User Interface Suggestion

Figure 1. Knowledge Map functions (i.e., buttons) wrap when any knowledge map has long name or description.

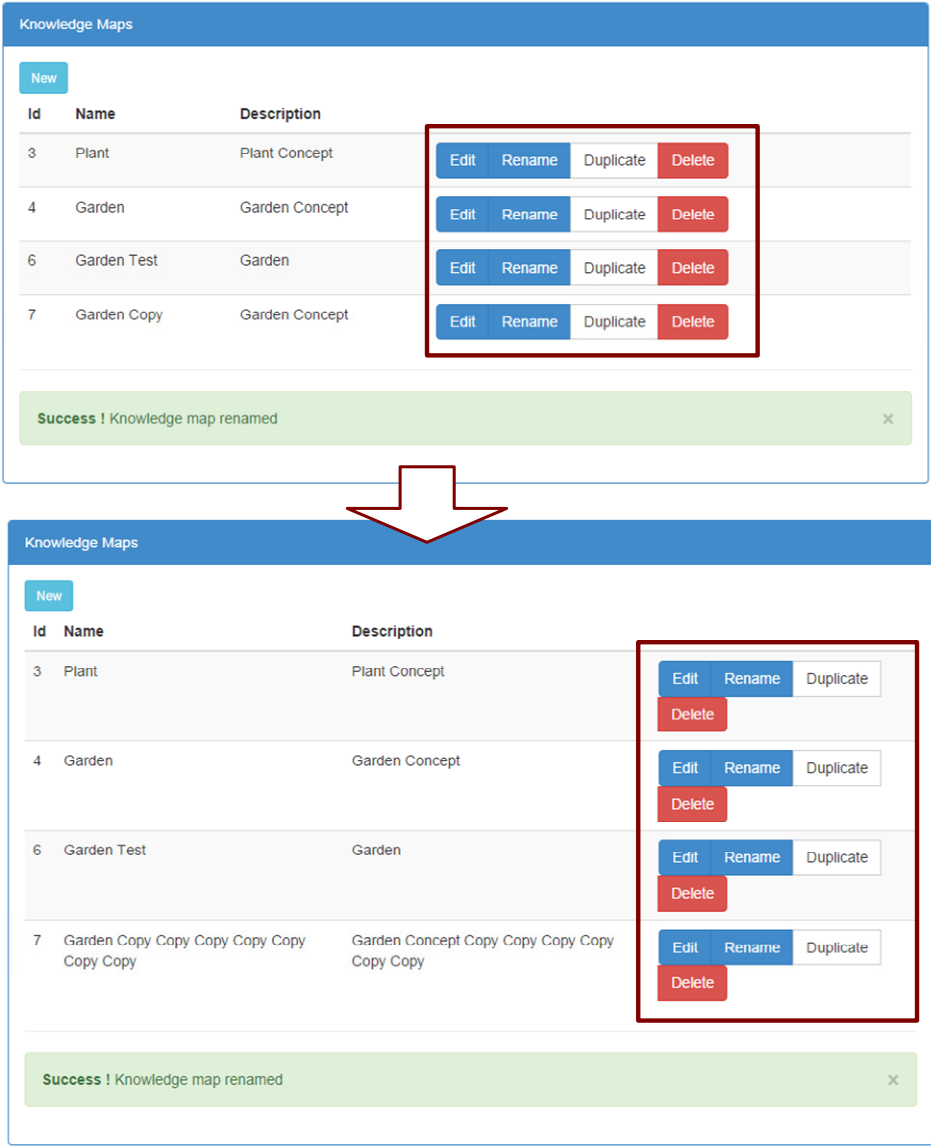
- When the name description of a knowledge map is too long, the buttons wrap as following figure shows. It would be better to fix the width of the Name and Description columns, so the buttons will never be wrapped to a new line.

Figure 2. Upper Function Bar after signed-in

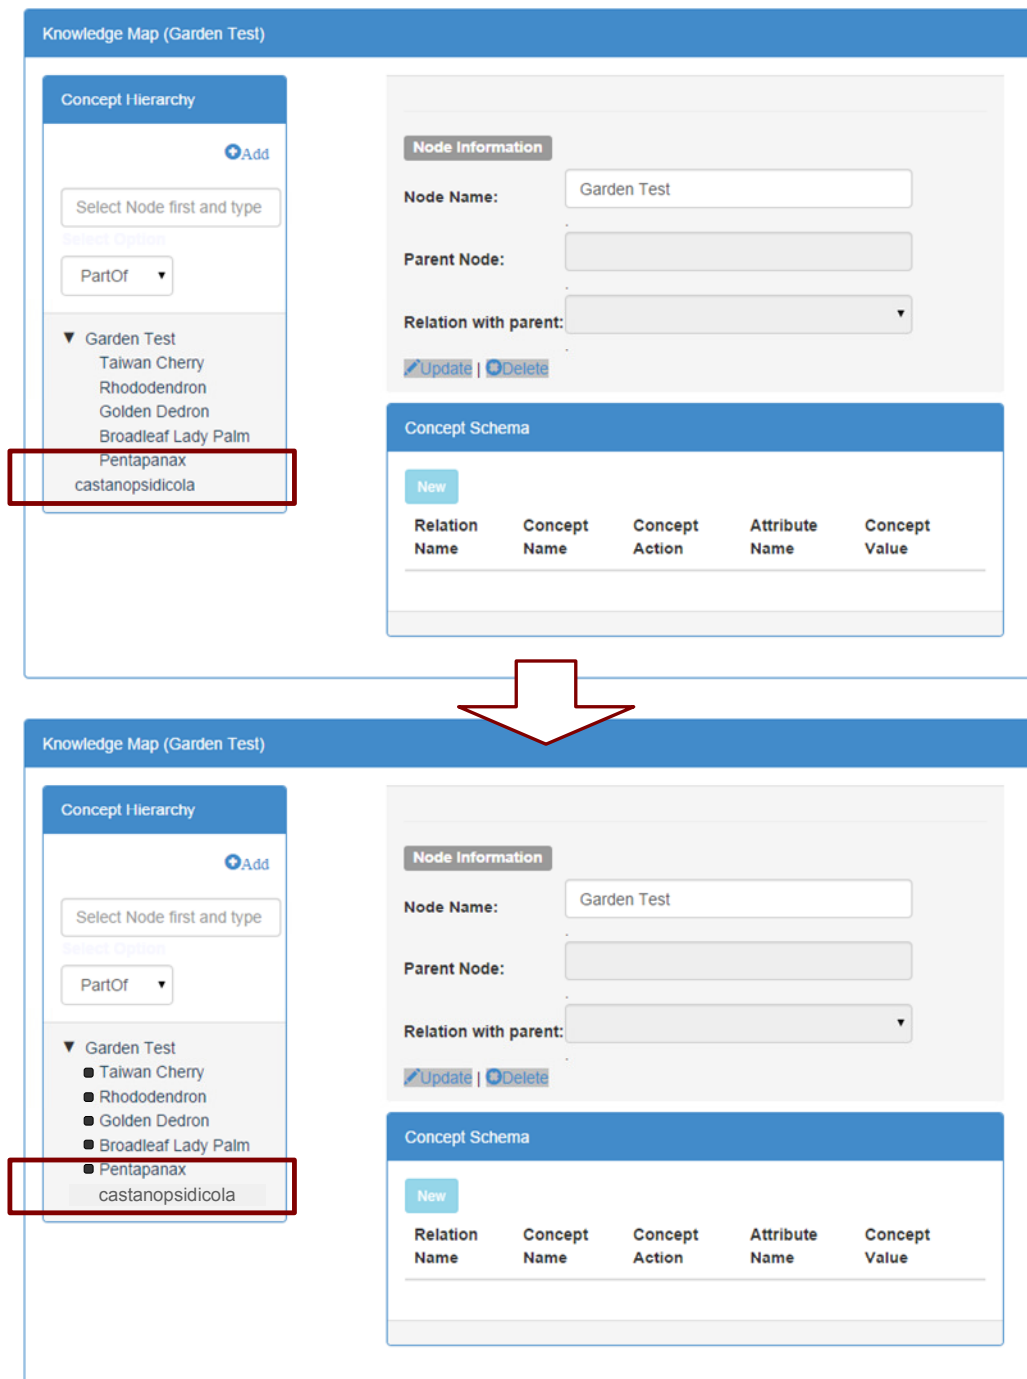
- When the node's name in Concept Hierarchy is too long, the text wrap. It would be better to use indent or bullet instead of space.

Figure 5. The original selected node is not selected.

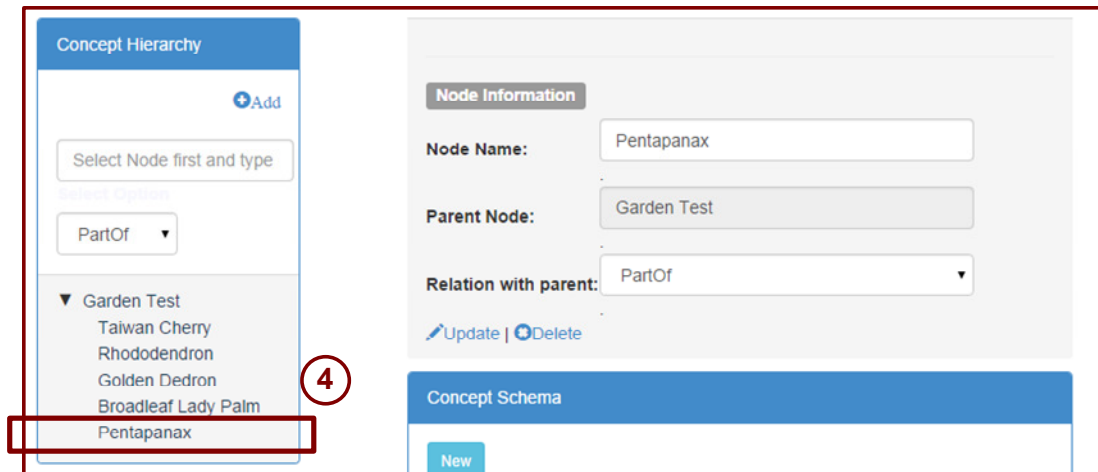
- After node's name updated, the original selected concept node is not selected in Concept Hierarchy, but the "Node Information" frame still shows the information of the original selected node.

Figure 6. Error occurred when update the un-selected node.

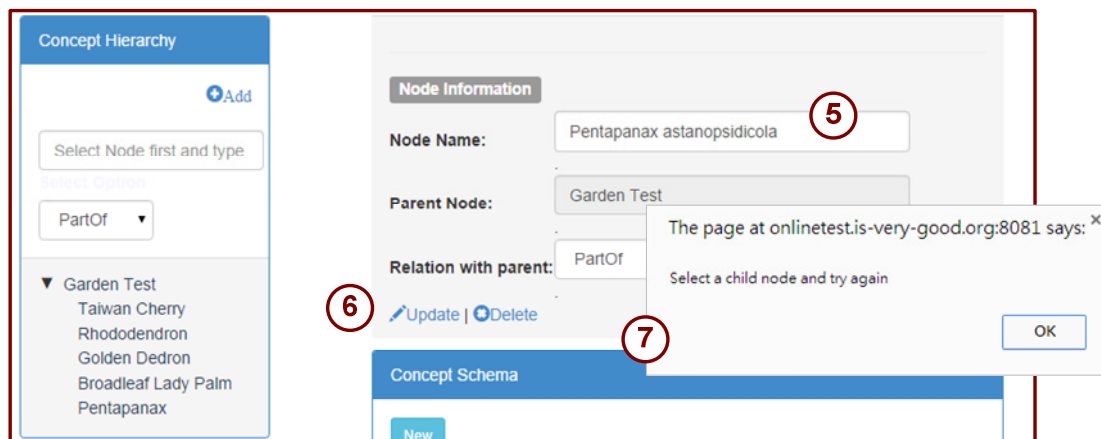
- Users might believe the original selected node is still selected. When they do the second update (step 5 and step 6 in Figure 6), the error shows (step 7 in Figure 6).
